CITY OF SAN ANTONIO

Re: Valley View Subdivision (Amendment)

MDP # 789-B

The City Staff Development Review Committee has reviewed Valley View Subdivision Master Development Plan (M.D.P.) # 789-B (Amendment). Please find enclosed a signed copy for your files. Your plan was accepted however please note the following:

70' TYPICAL STREET SECTION
SCALE: HORIZ. 1" = 10', VERT. 1" = 5'

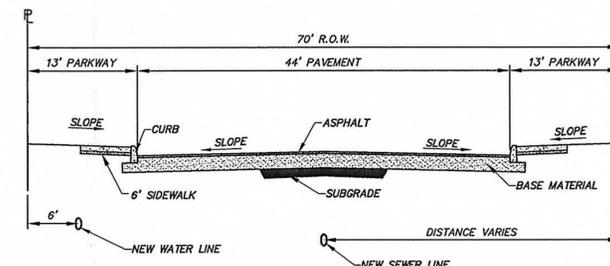
2. Construction of an internal collector street system approximately 1400-feet in length. Collector street design parameters consist of 70 feet of ROW and 44 feet of pavement (Table 506-3). The proposed collector street shall have no houses fronting (UDC 35-515, (c)(4)).

VALLEY VIEW SUBDIVISION
PREVIOUSLY KNOWN AS BINZ ENGLEMAN SUBDIVISION
MASTER DEVELOPMENT PLAN

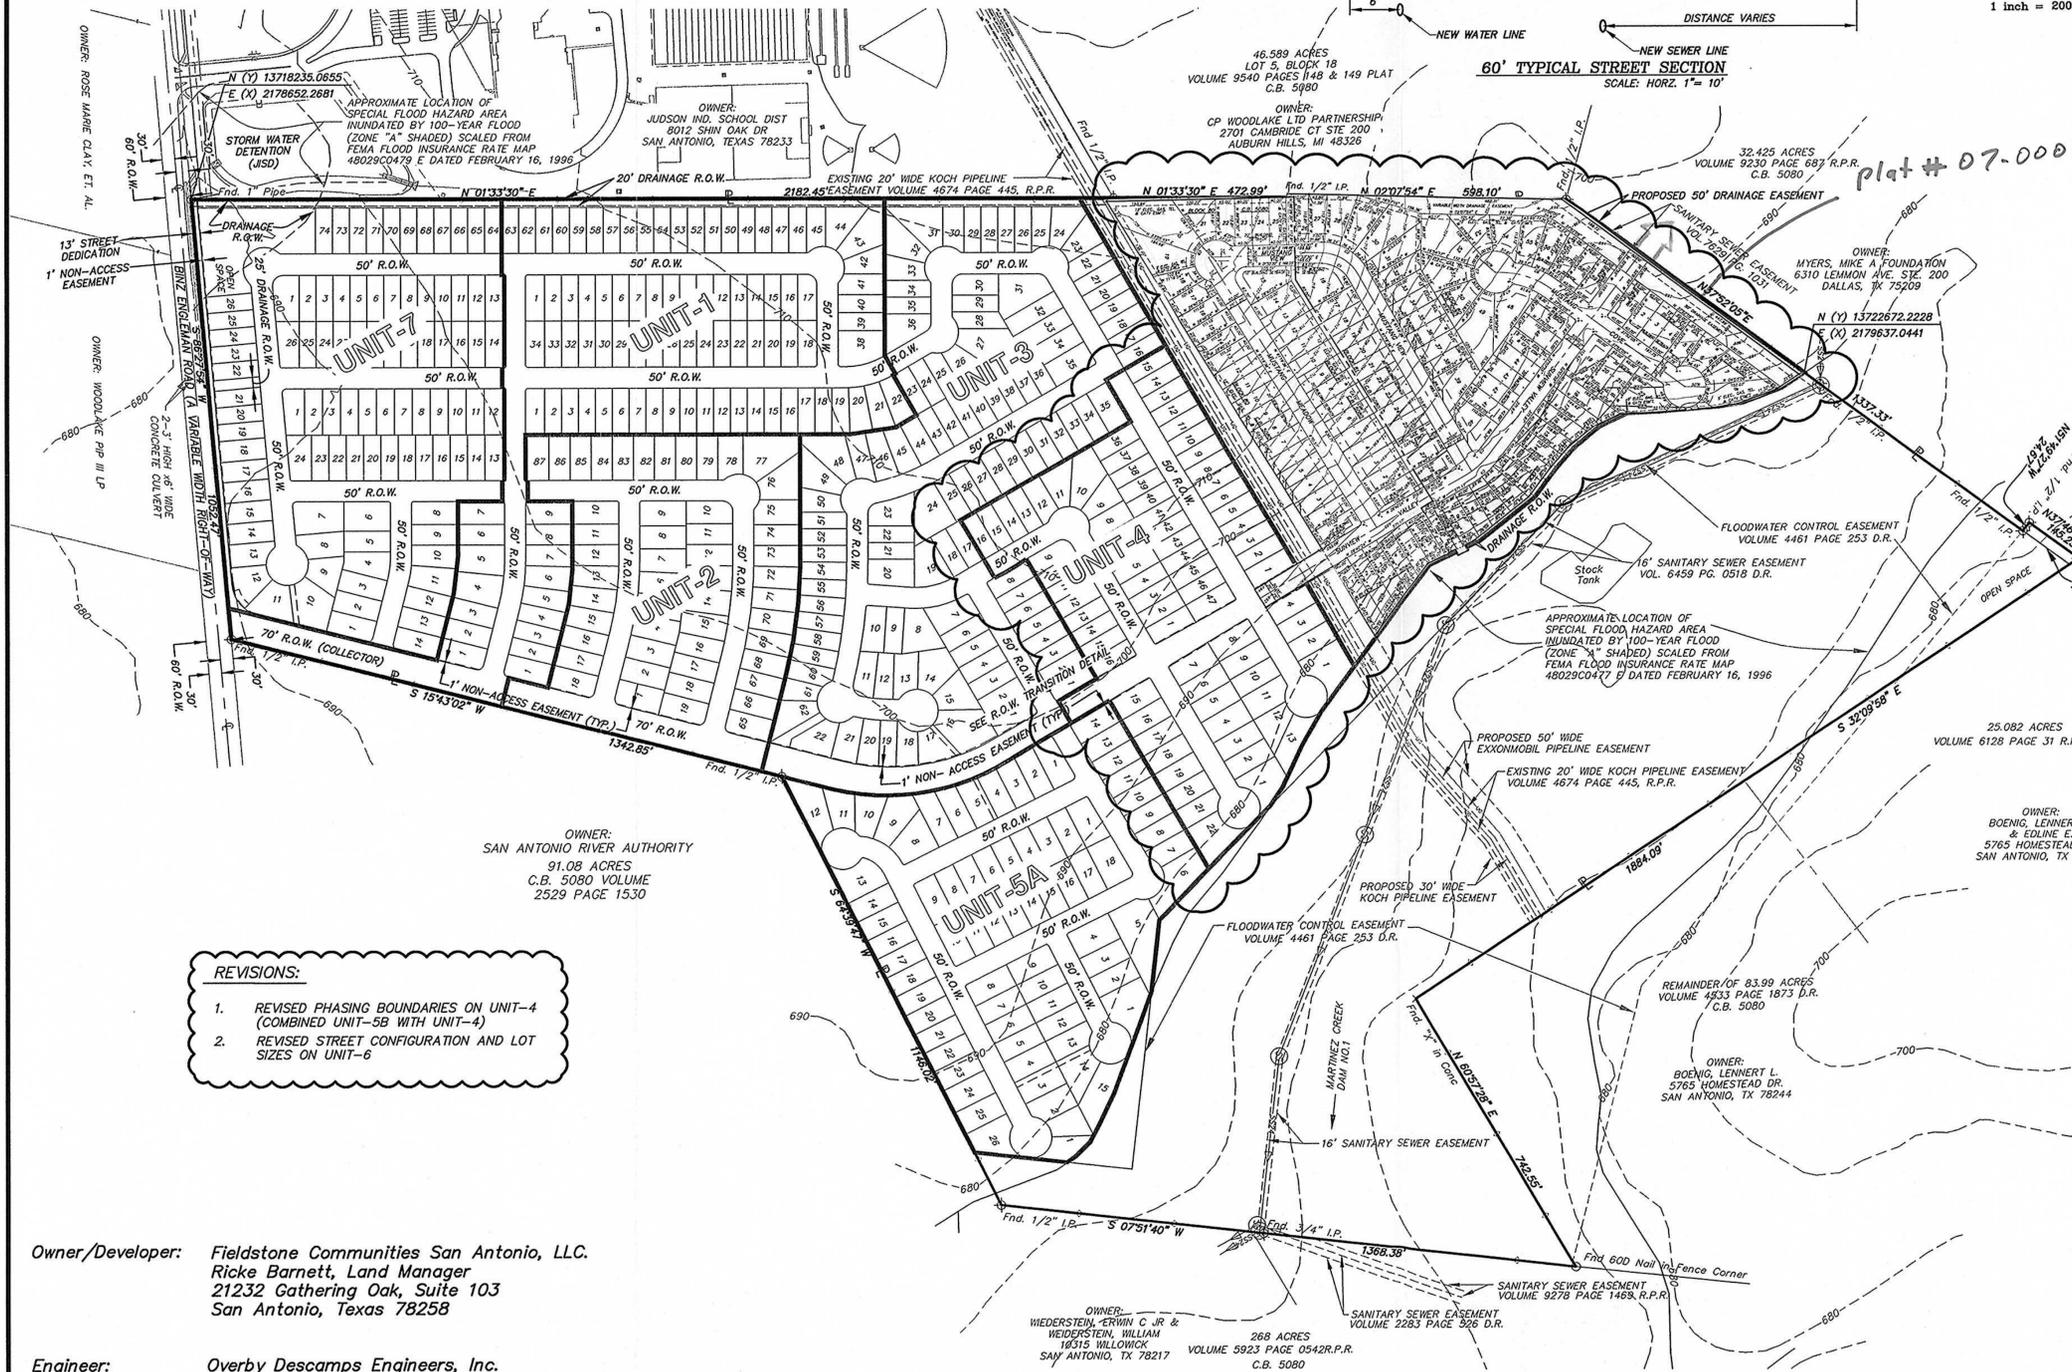
- **Development Services** as part of the conditional approval, cite at the time of platting Unit-6 shall satisfy this section of the City of San Antonio Unified Development Code (UDC) by the following means:

1. Provide and construct the street stub-out and drainage culvert in accordance with the UDC or
 2. A variance request to section 35-506, (e) Connectivity, (2) Projecting Streets before the Planning Commission

- **Storm Water Engineering** as part of their conditional approval cite the following:
 1. Please note that according to Walzem Farms Subdivision drainage study, June 2002, the 100yr ultimate development causes the Martinez Dam Site#1 pool level to rise to an elevation of 676.38. All structures adjacent to the inundated area must be at level two (2) feet above this water surface elevation. The crest of Martinez Dam Site#1 is at an elevation of 680.6 feet.

2. In case a storm event of a higher magnitude hits this general area, the floodplain inundation may cause major flooding in the adjacent areas of the dam. The hydraulic inadequacy of the dam makes it unable to pass the Probable Maximum Flood (PMF). The proposed development will be inundated up to the elevation when the breach occurs and will be above the crest of the dam. Even floods of lesser magnitude, assuming routing starts at the emergency spillway, will also flood the proposed development. The consultant must determine this elevation and routing of the PMF is needed. The engineer

1. Binz-Engleman Road- The Developer shall dedicate 43 feet of ROW (Ordinance 98282, October 2, 2003 Major Thoroughfare Plan (MTP)) from the centerline of Binz-Englemen Road (Secondary Arterial Type A – Uniform Development Code (UDC) 35-506, (g), (2) adjacent to this proposed project. The total length of property frontage is 1052.47- feet as indicated by submitted MDP.

3. Construction of an internal Local B Street approximately 1200-feet in length from the end of the proposed collector to Unit 6 (UDC Appendix A, Definitions of Local A and Local B).

4. All Roadways shall conform to UDC 35-506(c), (1), Table 506-1: Functional Classification System Description.
 5. The developer shall be responsible for upgrading the intersection of Binz-Engleman Road and the Collector Street. This includes a sufficient left-turn storage lane on eastbound Binz-Englemen Road, with a bay taper and transition (UDC-35-506,(m),(2) and a right-turn deceleration lane (westbound Binz-Engleman Road) with a storage lane and bay taper as it relates to the submitted TIA traffic counts, (UDC –35-502 (a)(7), subsection C.

- Section 35-506 (e) connectivity, (2) projection streets of the Unified Development Code requires connectivity to adjoining areas not subdivided. At the time of platting Unit-6, we will either provide connectivity to adjoining areas not subdivided or request a variance to section 35-506.
